UNITED STATES PATENT AND TRADEMARK OFFICE

APPLICATION NO.	FILING DATE	FIRST NAMED INVENTOR	ATTORNEY DOCKET NO.	CONFIRMATION NO.
09/678,414	10/02/2000	David W. Carlson	100-13604	4381
33402 7590 05/15/2007 LAW OFFICES OF MARK C. PICKERING P.O. BOX 300 PETALUMA, CA 94953			EXAMINER KEBEDE, BROOK	
			ART UNIT 2823	PAPER NUMBER
			MAIL DATE 05/15/2007	DELIVERY MODE PAPER

Office Action Summary	Application No.		Applicant(s)	
	09/678,414		CARLSON, DAVID W.	
	Examiner		Art Unit	
	Brook Kebede		2823

DETAILED ACTION

FIG. 2D

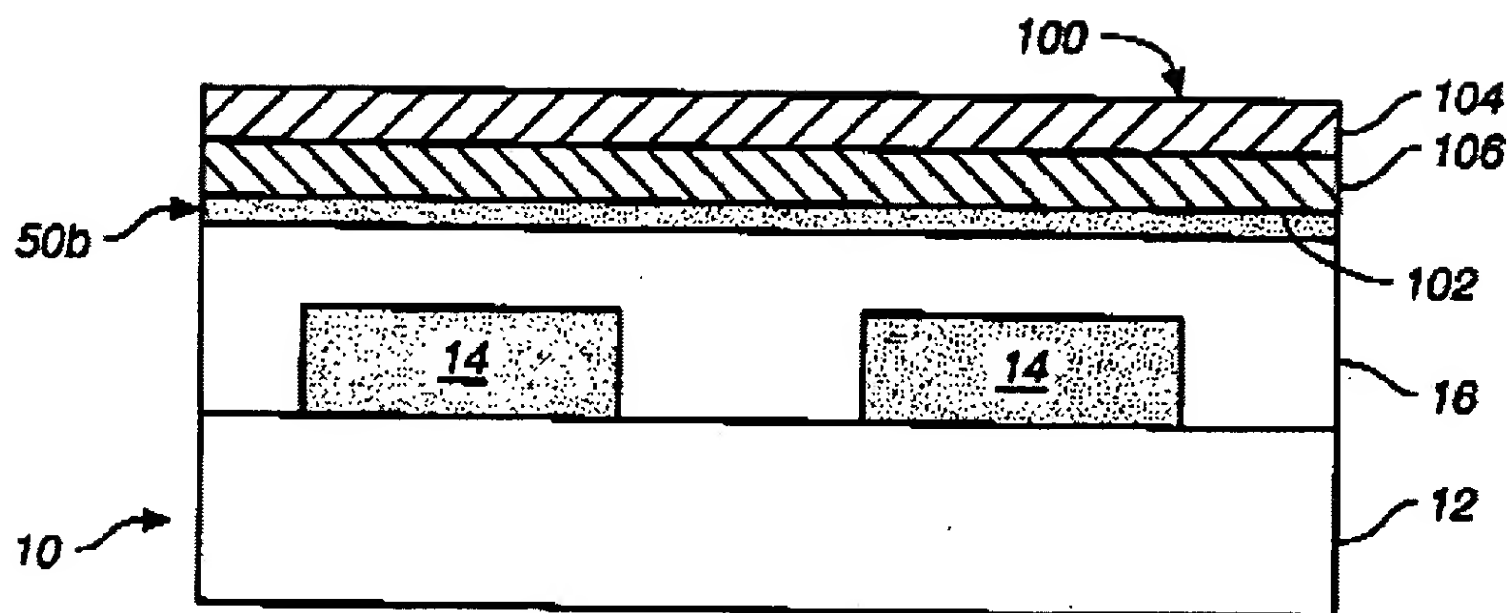
Applicant further argued that "As shown Fig. 2C, Li teaches the native oxide layer 18, *the second material*, has been removed, from polysilicon 16, the first material, but Li totally fail to teach or suggest that the polishing continues until substantially all the native oxide layer 18 has been removed at which time polysilicon layer 16 has a substantial planar top surface as required by claims..."

In response to the applicant's argument, it is respectfully submitted that Li et al. '368 disclose all the claimed limitations the instant application as claimed in claims 31-36, 38-46 and 49-52 as applied above. For example, as shown in Fig. 2D and presented herein below, the first material layer 16 does actually polished to have planar surface prior layer 50b, 106 and 104 are deposited. The removal of the second material layer 18 and planarizing of the second material 16 is happened concurrently within short period of time by CMP process (see also Col. 6, lines 1-5). In addition, with respect to applicant's argument, it is not clear how could be possible that polishing of layer 16 with out removing of layer 18.

FIG. 2G

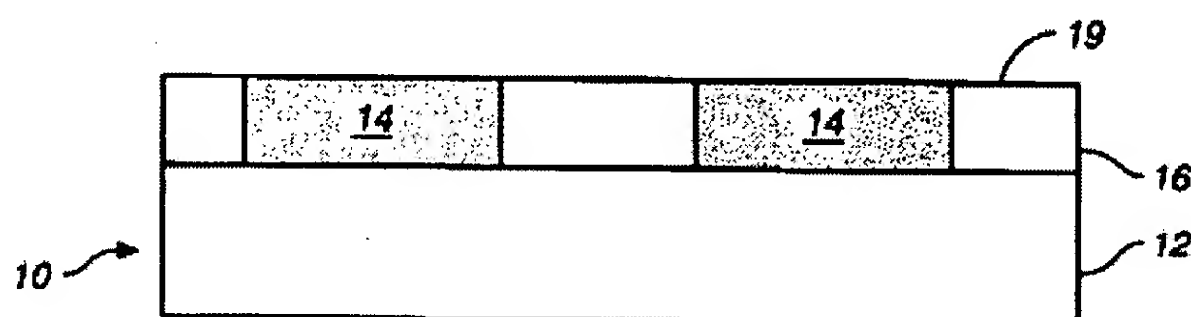
After the CMP process and removal of the material layer 18, the first material layer 16 having a substantially planar surface 19 as shown in Fig. 2G herein below.

Further in response to applicant's contention, it is respectfully submitted the instant application claimed invention does not specifically disclose to the degree of certainty that instant application CMP process will result a perfect planar surface that cannot be achieved by the CMP process of Li et al. '368. There is no evidence can be found in the instant application to the contrary of Li et al. '368 disclosure.

FIG. 2I

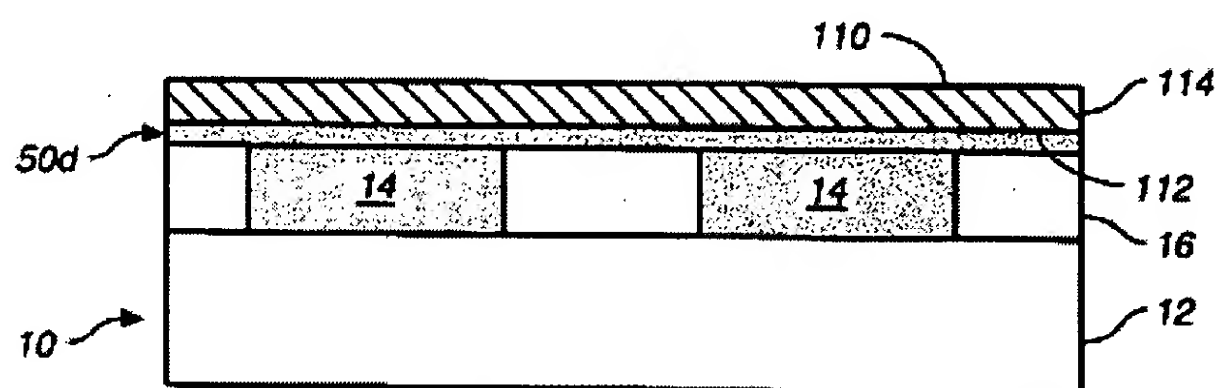
Applicant further argues that "Li fails to teach or suggest formation of third material as claimed ..."

In repose to applicant's argument, it is respectfully submitted that Li et al. '368 disclose all the claimed limitations of the instant application as claimed including forming of third material over the planarized second material 16. For example, Fig. 2I as shown below material layer 114 is meets the claim language third material layer as applied in the rejected claims in Paragraph 4 above.

Further in response to applicants contention that "*Li does not teach or suggest* wherein the third layer is a mask *layer ...*," it is respectfully submitted that "mask" layer does not have any special meaning as claimed in claims 39 and 50 because applicant does not define what the mask layer entails or represent in terms of it function and usage. Since "mask" has a very broad interpretation and function in the semiconductor industry, the "pad" layer is analogous to "mask" for CMP process. In addition based on the plane interpretation of the "mask" and examining of applicants evidence in Appendix "C", it is respectfully submitted examiner's interperation is proper to consider the pad layer as a "mask" because the invention CMP process and "pad" layer used as mask during CMP process in the art. With function and/or meaning of "mask" in the instant application, it is interpreted that Li et al.'s "pad" layer meets the scope and meaning of "mask". *"See In re Paulsen, 30 F.3d 1475, 1480, 31 USPQ2d 1671, 1674 (Fed. Cir. 1994).*
